PRINTING SITE PLAN

PROJECT	FOGO DE CHÃO	FOGO DE CHÃO
1500 E. Highway		
Deerfield Beach, FL 33442		
Ph (954) 428-1500		
Contractor	RCI Associates, Inc.	
422 SW 12th Avenue		
Deerfield Beach, FL 33442		
Ph (954) 428-1500

FIRE SERVICE

4300 BELT LINE

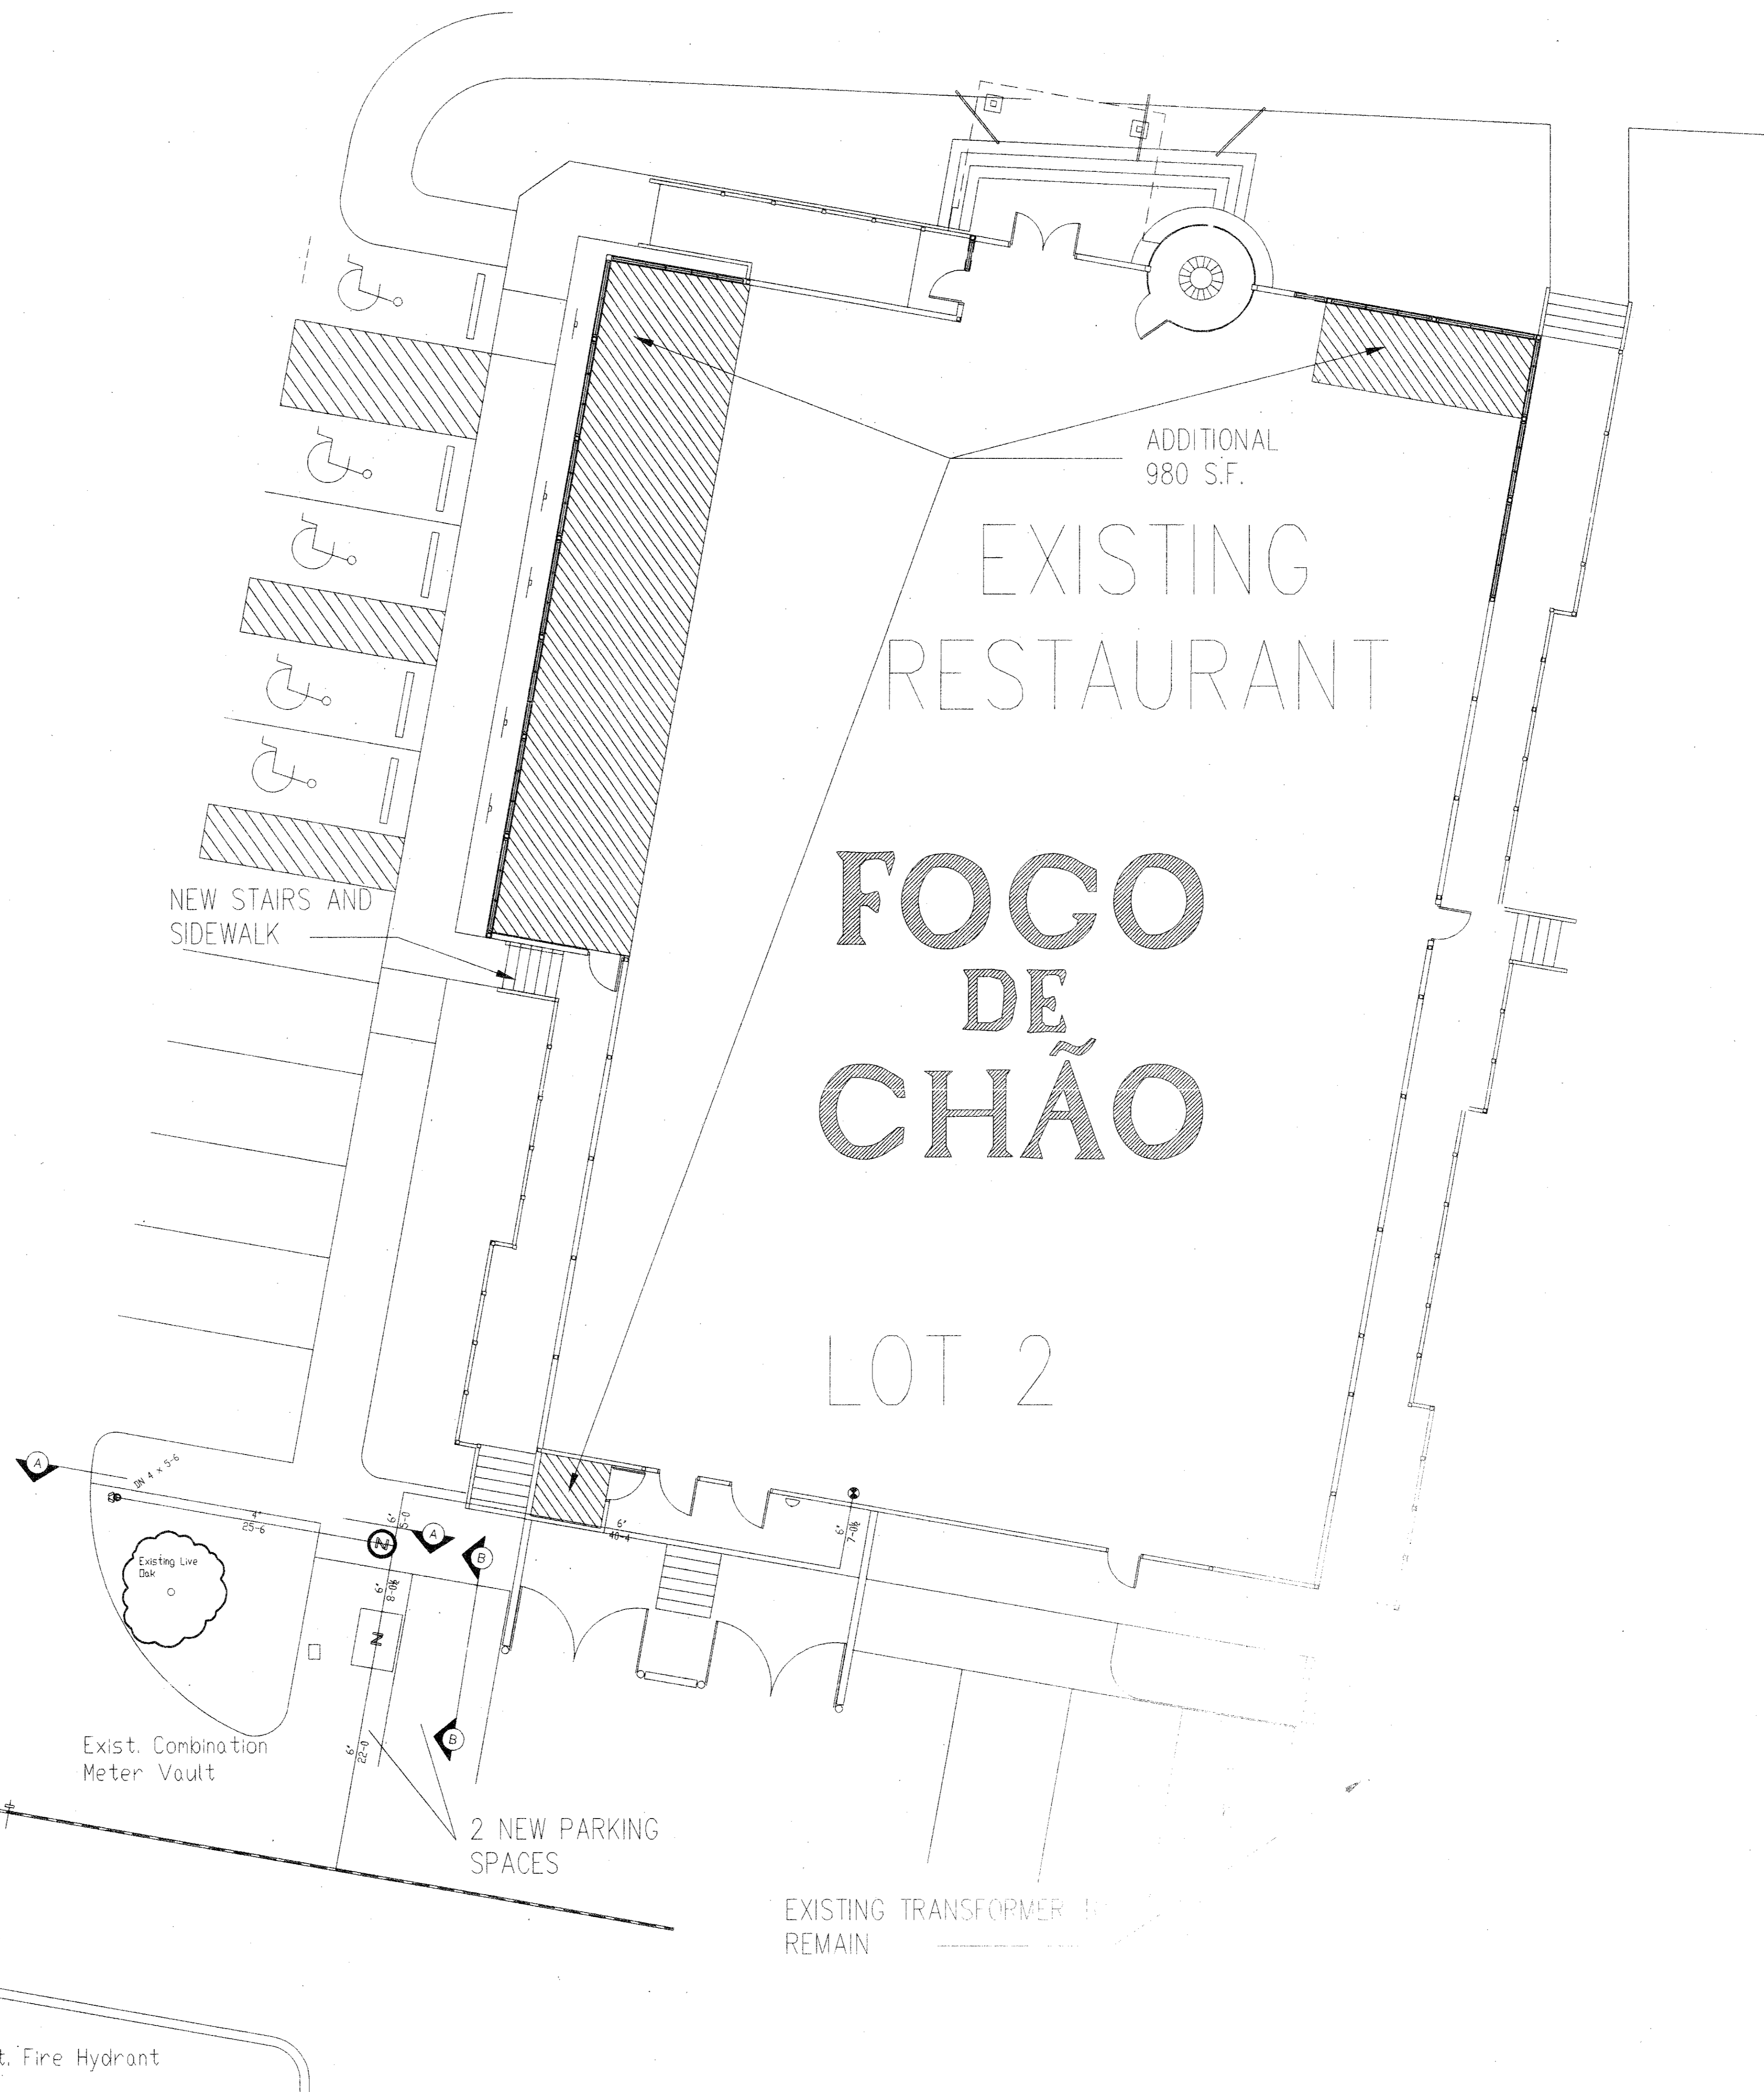
1) USC-REC 412 Approval
DCDA required (Fire service)
2) All water to have remote (back-pipe) registers/readers.
3) DCVA required on domestic service.
DEW 8/27/01
